Date	10 February 2026
To	Jon Bright, Project Director – Waitaha Hydro Scheme Westpower Ltd
From	Dougal Clunie
Project advice provided for	<i>Waitaha Hydro Scheme</i>
Qualifications	<i>BE(Hons), PhD and Appendix A</i>
Code of Conduct	<i>Appendix B</i>
Documents referred to	<i>Waitaha Hydro Scheme Substantive Application Appendix 3 Project Overview Report, Appendix 19: Sediment Report, Appendix 42: Conceptual Scheme Design Drawings¹</i>
Signature

1. I respond, as relevant, to various engineering design matters contained in the peer review reports prepared by the Panel’s technical advisors (the “**Review reports**”):
 - (a) Waitaha Hydro Power Review of Intake Engineering and Fish Passage (26 January 2026) prepared by Mr Paul Morgan (the “**Morgan report**”); and
 - (b) Statement of Evidence of Dr Jon Tunnicliffe on River Geomorphology (23 January 2026) (the “**Tunnicliffe report**”).

Figure 1: Indicative rating curves showing modelled headwater level upstream of weir (HWL) and tailwater level (TWL) 25m downstream, as well existing headwater level upstream of rock bar.

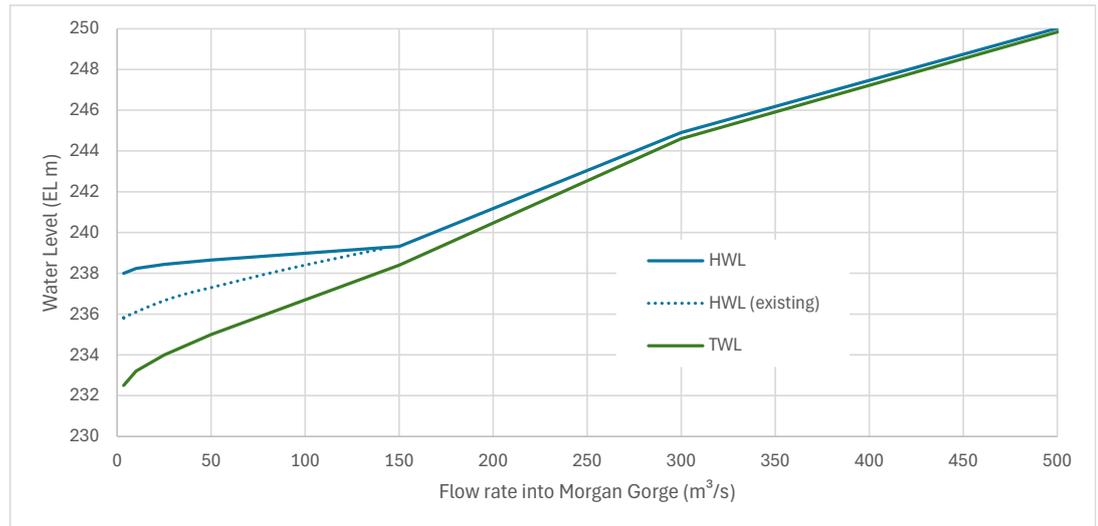
27. The Morgan report questions "*Does the weir need to be 7m high as greater height has implications for sediment but also energy to dissipate and environmental effects including upstream fish passage difficulties?*" To clarify, 7m is the **maximum** height of the main weir structure above the excavated sluice channel. This depth is necessary to allow the sluice to keep the submerged intake clear of sediment.

28. The weir crest itself is at EL 238 m, approximately 3 m above the 8 m wide 'notch' in the existing rock bar riverbed at this location. The effect of the weir as a hydraulic control on upstream flows is an approximate 2 m increase in water surface at low flows, decreasing at higher flows to be zero as the weir is drowned by the choking effect of the gorge at flows of around 150 m³/s (**Figure 1**).

29. For fish passage effects, the relevant height would be the difference between tailwater level and weir crest elevation, which is approximately 5.5 m at the lowest bypassed flow condition (3.5 m³/s), reducing as flow into Morgan Gorge increases as illustrated in **Figure 1**. In the existing situation there is a 2-3 m drop in water level across the weir and headworks area in low flows
